A few measurements with the Protoboard Interface Card

O. Le Dortz, Yoann Le Roux (LLR, Palaiseau, France)

We reproduced the measurements we've made at IJClab when injecting a pulse at the LED CTRL input

Initial Scheme (cf p.5)

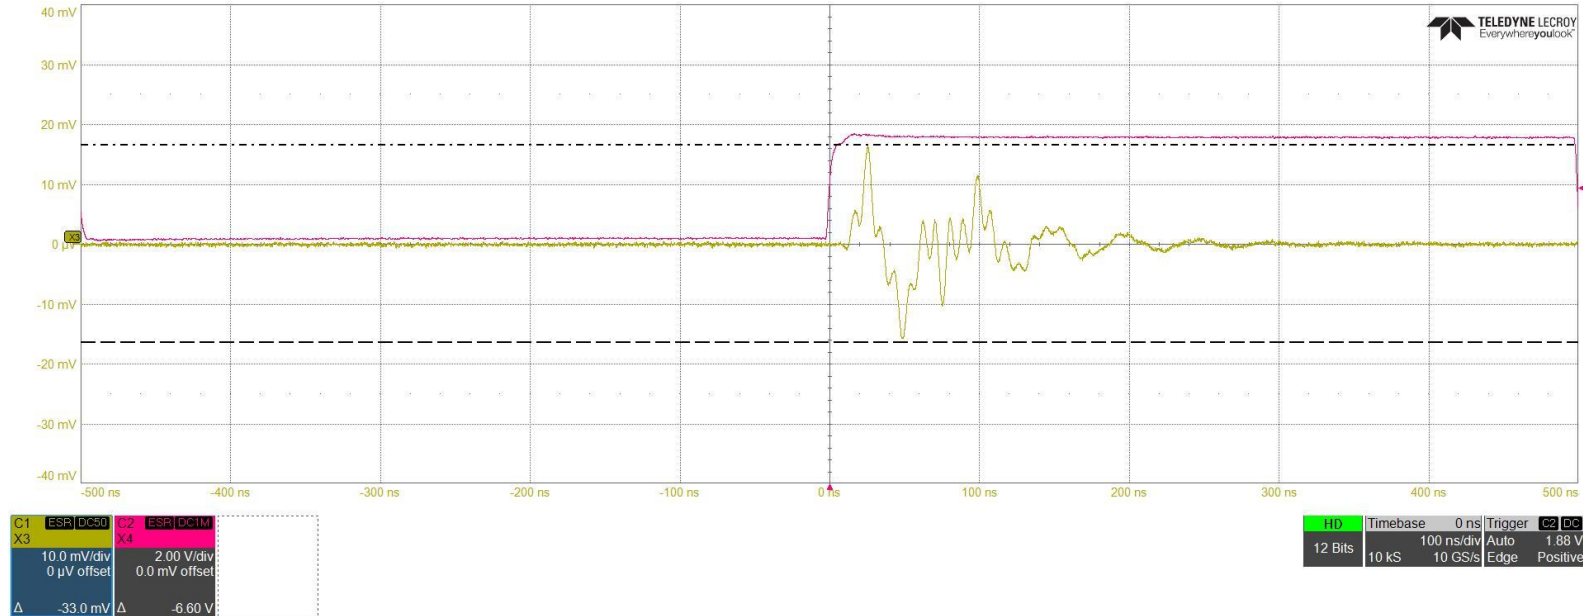
No GND connection of the flat cable connectors pins (floating shields)

=> The amplitude of the spikes significantly varies when moving the cable. Here, "best" case ($\sim 33\text{mV pp}$)

Conclusion: soldering the 2 GND pins on each connector **recommended** (if not already done)!

After shield pins soldering

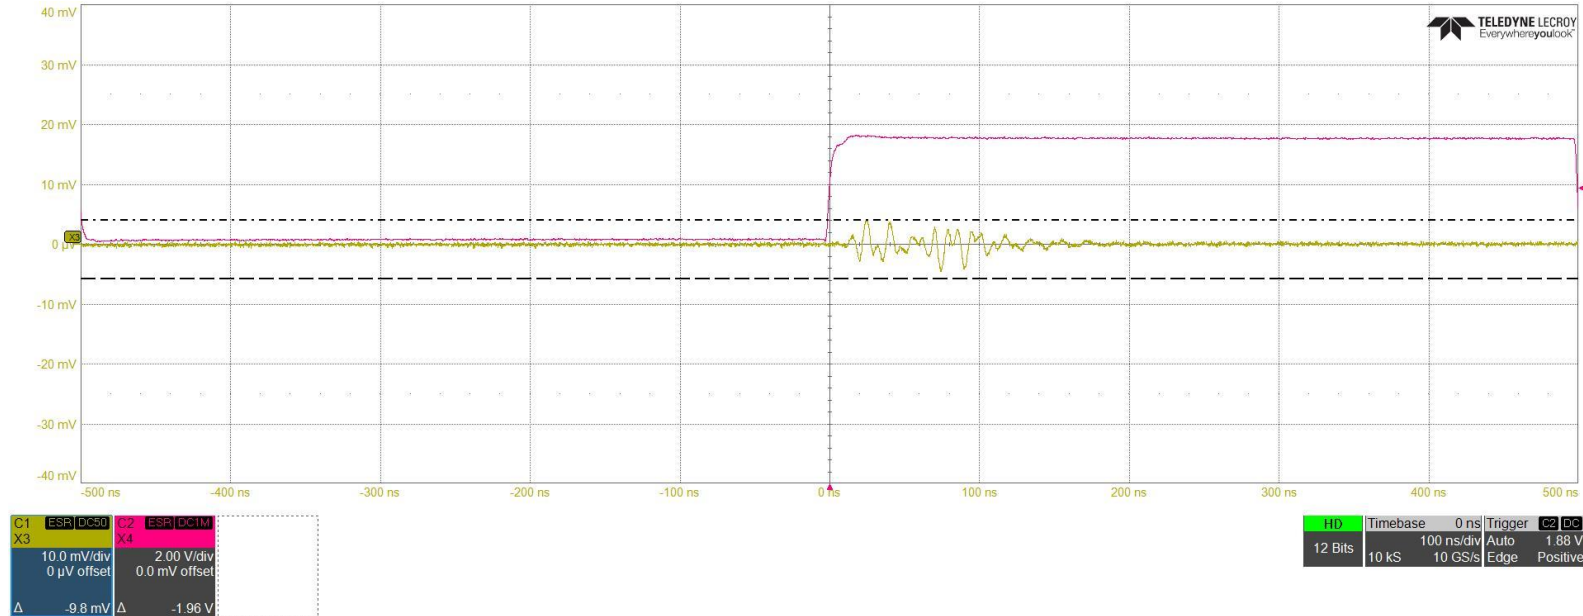
Noticeable reduction of the spikes amplitude ($\sim 10\text{mV pp}$)
